Subject: Rubbing Noise From Rear of Vehicle (Install Retainers to Wheel Liner) #06-08-65-001 - (04/28/2006)

**Models: 2006 Pontiac Solstice
2007 Saturn Sky**

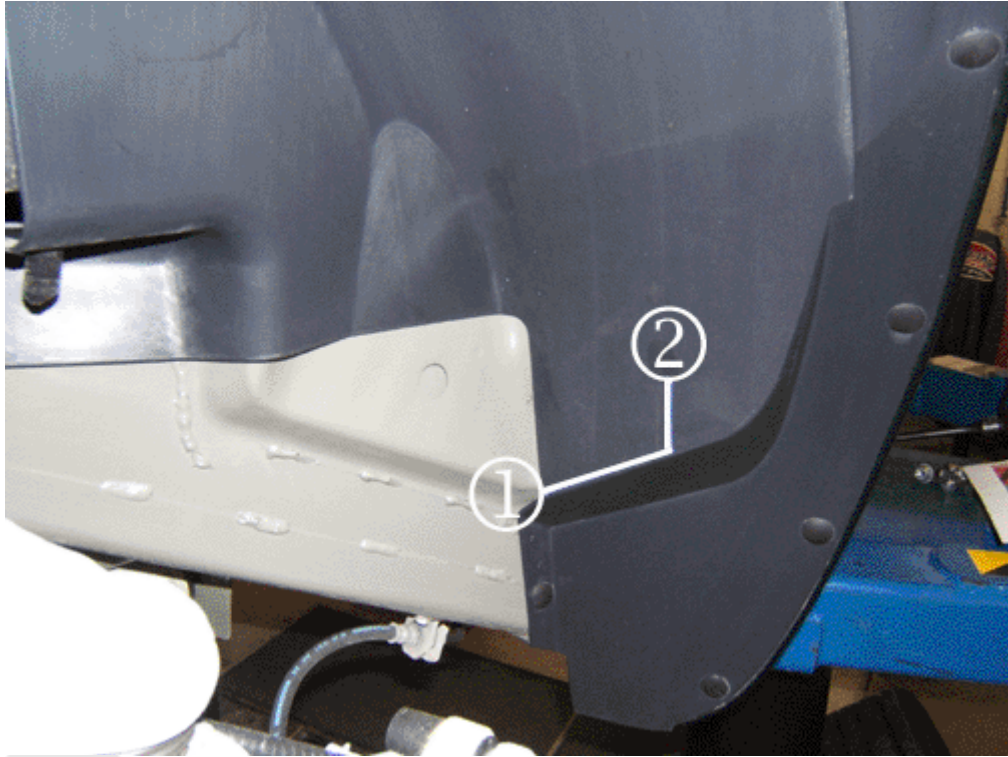
Some customers may comment on a rubbing noise from the rear of the vehicle.

This condition may be caused by the inner wheel liner making contact with the tire .

Install new retainers in the left and right inner wheel liner following the procedure below.

2. Make a measurement from the corner 90 mm (3 ½ in). The second measurement will be to measure up 40 mm (1 ½ in). Refer to the illustration.
3. Drill a hole through the plastic wheel liner and the sheet metal using a 6 mm (15/64 in) drill bit.
4. Drill the hole larger in the plastic liner using a 8 mm (19/64 in) drill bit to eliminate contact with the retainer.
5. Apply SuperLube® with PTFE, P/N 12371287 (in Canada, P/N 10953437), to the end of the retainer and install the new retainer. You must push firmly on the retainer to fully seat it.
6. Install the wheel and tire.
